Access Compliance Report Public Rights-of-Way (Curb Ramps)

Main Street: LA_COLINA_DR		Cross Street: RED_HILL_AVE		Location:	S
ADA ID: RPRK220107121039	Ramp Type: Type 7 - Directional 2	Initial Pass/Fail: Fail	Overall Compliance: No	Severity Score:	2
Codes/Mitigation Info/Possible Solution			Field Measurements/Component Compliance

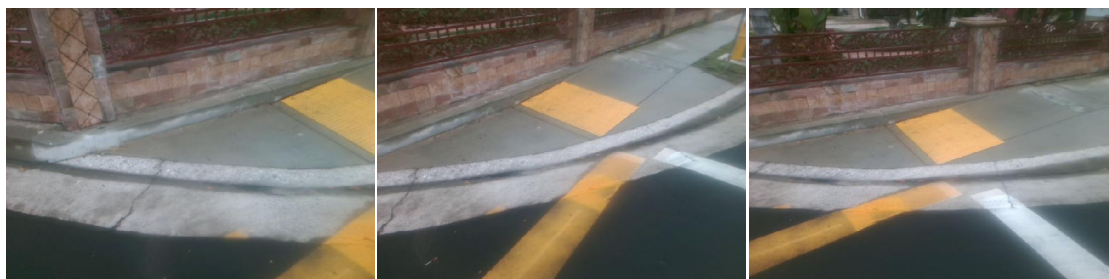
R304.5.3, R302.7.2, STD 1115

Remove & Replace Entire Ramp. Grind Gutter Lip.
